**Re: Stormwater Review
58 Massasoit Ave, Sudbury, MA**

Our firm revised the plans and Stormwater Report to address the comments received in the email dated June 23, 2023 for the above captioned project. The following is a response to comments: (Response in italics)

STORMWATER MANAGEMENT REPORT

58 Massasoit Avenue
Sudbury, Massachusetts

JOB No. 17,240
DATE: 7/6/2022
SCALE: 1"=20'
SHEET: 2 of 3
PLAN #: 27,611

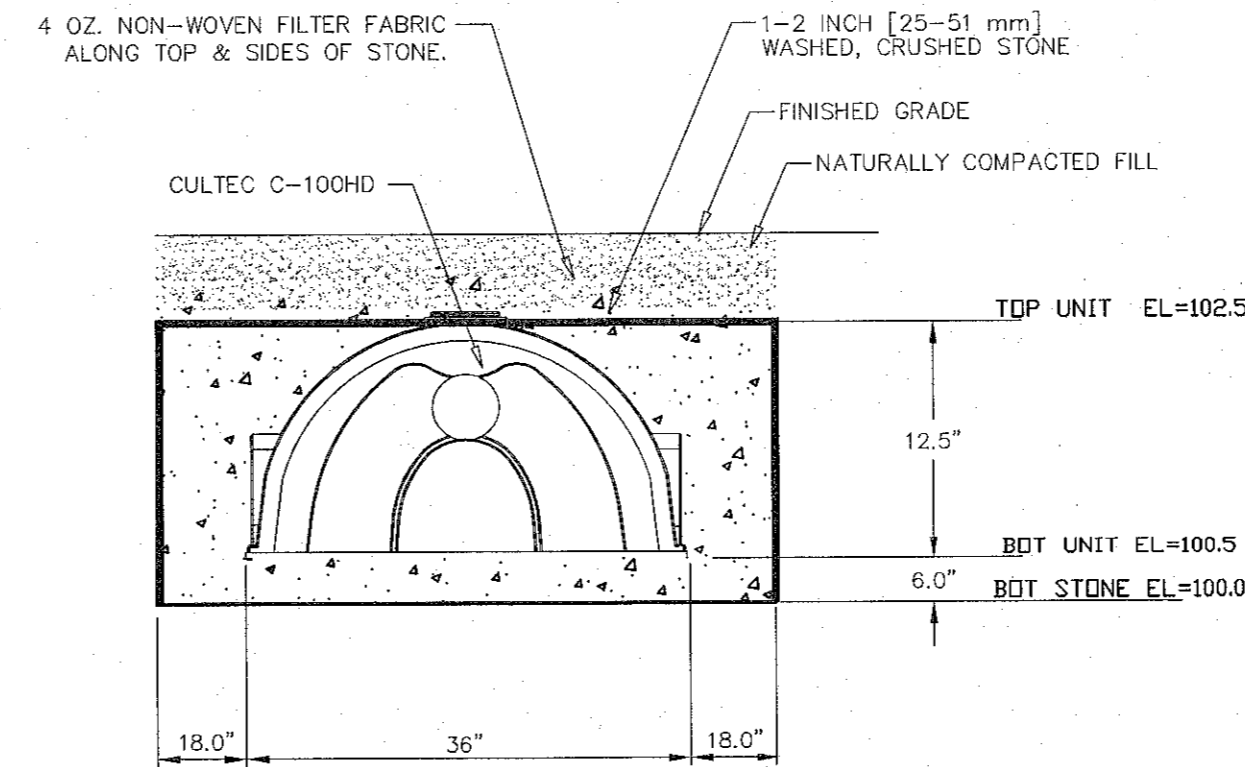
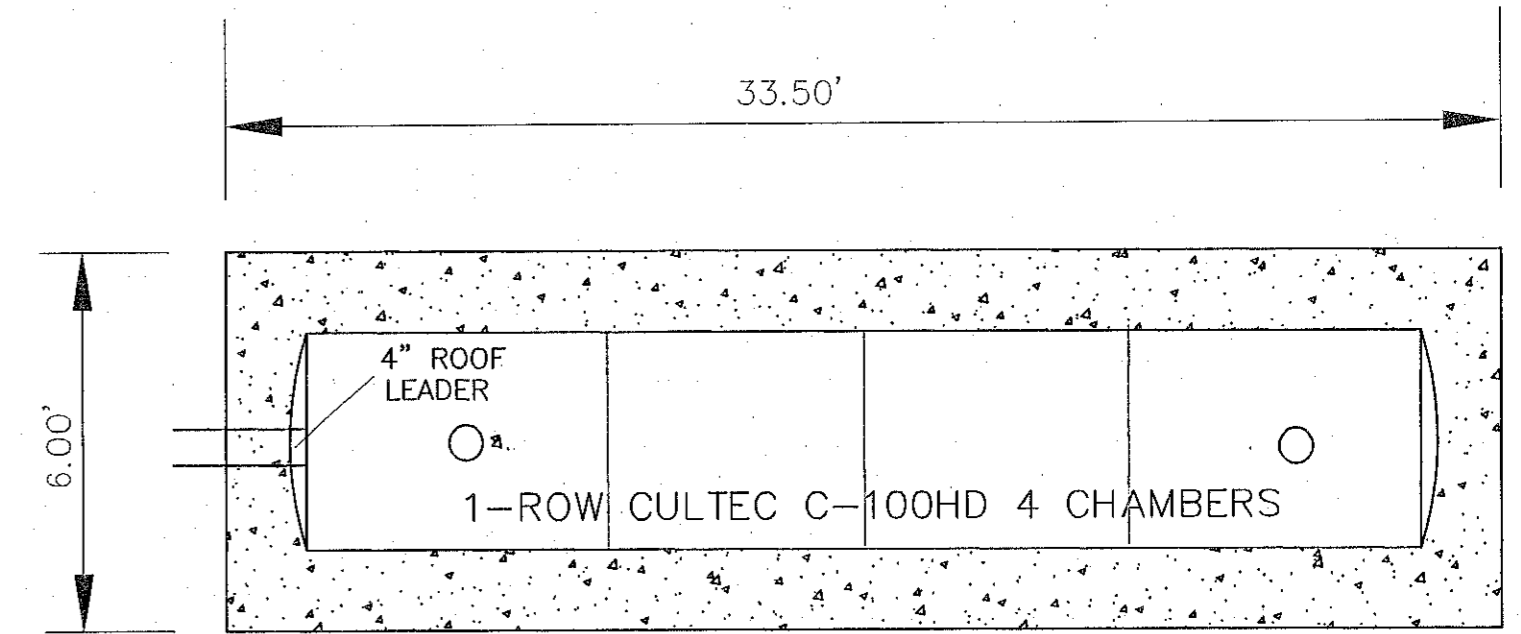
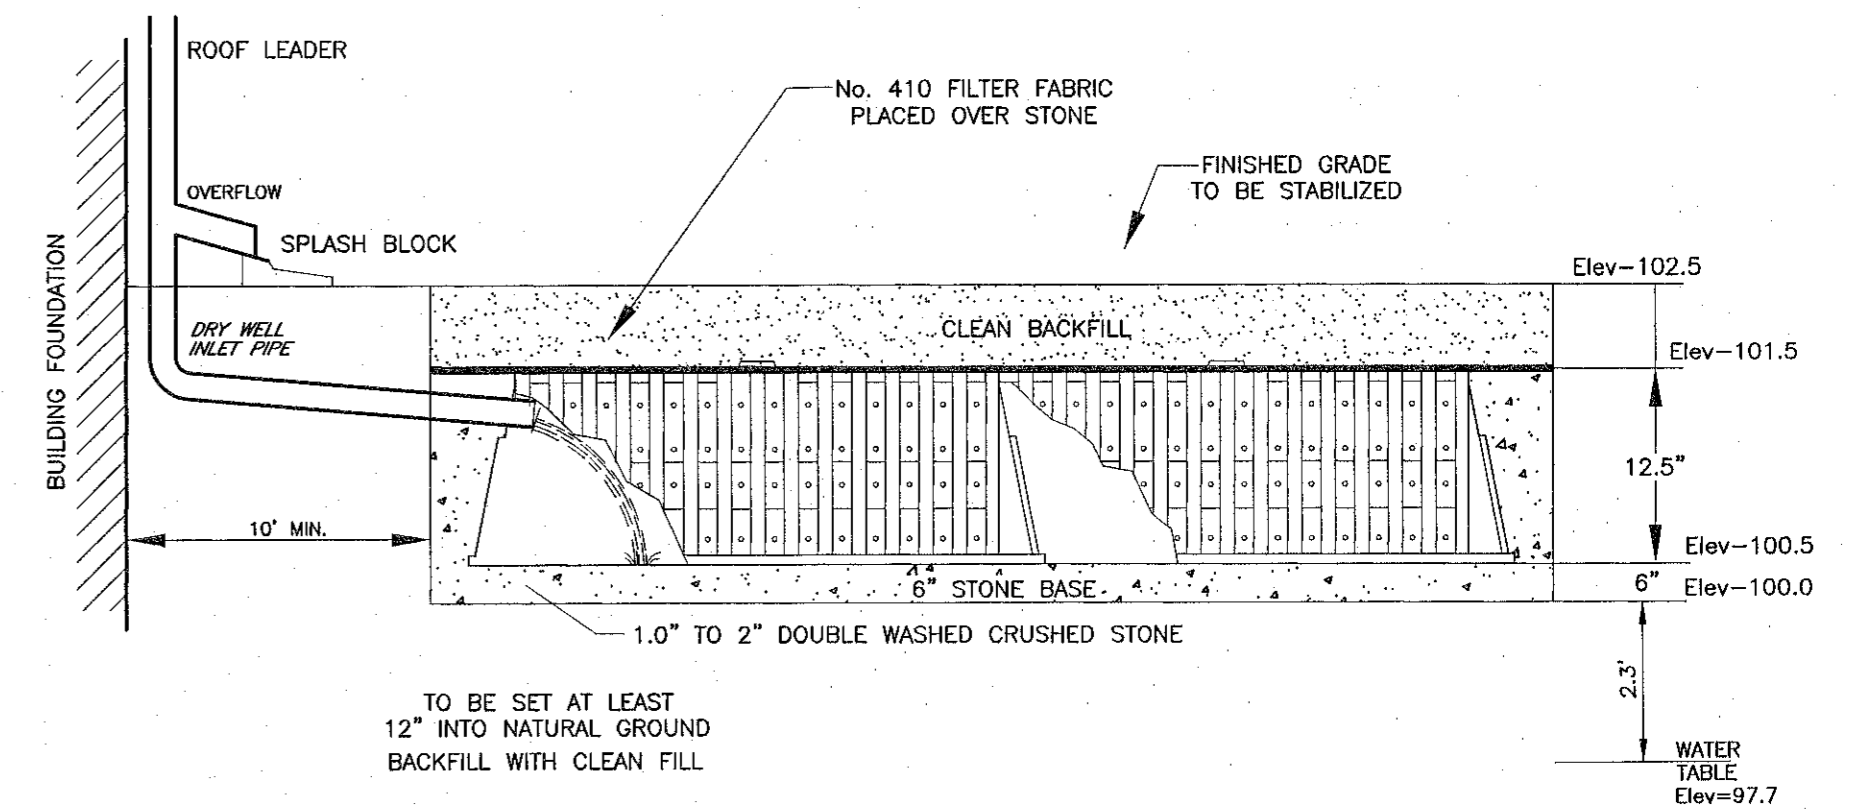
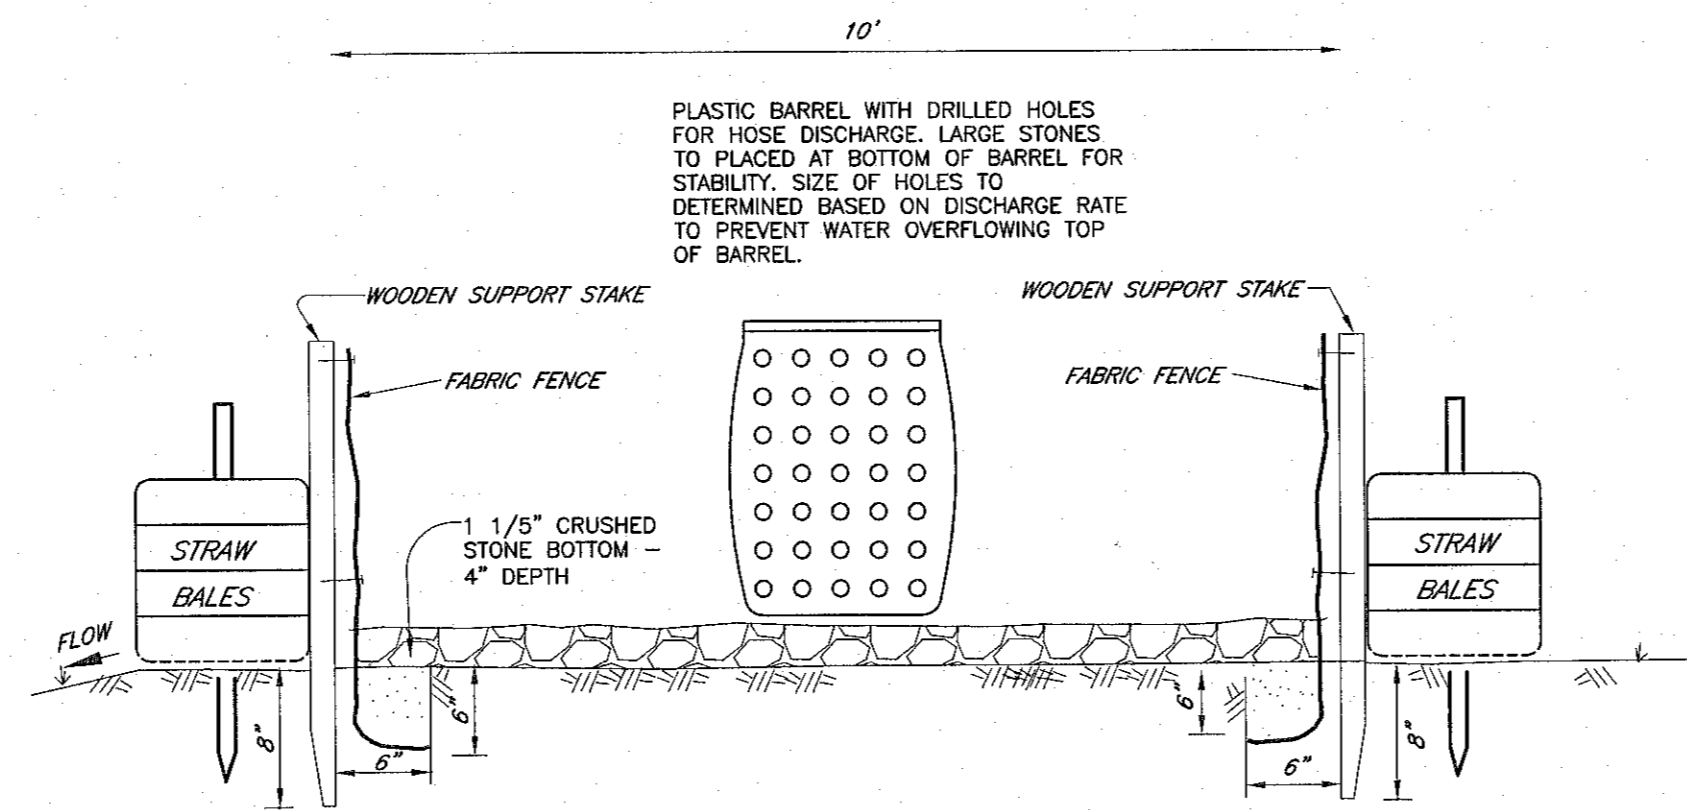
- No outlet shown at chambers. If system fails the Applicant shows overflow at down spout.
No additional comment. Overflow as stated.
 - Plan shows 226.6 CF of recharge volume provided but it may be closer to 180 CF depending on the depth of stone below the chamber (6”, 12”, or 18”). Applicant should confirm depth of stone or confirm volume listed.
Revised See Plan Sheet 2 of 3.

ALL ROOF RUNOFF TO BE DIRECTED TO RECHARGE SYSTEM.
PROPOSED ROOF AREA = 1,774 S.F.
VOLUME REQUIRED FOR 1" OF RUNOFF OVER ROOF AREA:
1,774 S.F. x 1" = 148 C.F.
VOLUME PROVIDED CULTEC RECHARGER DRAINAGE SYSTEM:
CULTEC RECHARGER C-100HD 4-UNITS
STORAGE VOLUME PROVIDED = CHAMBER + STONE STORAGE
= 56.8 cu.ft. + 101.2 cu.ft. = 158.0 cu.ft.
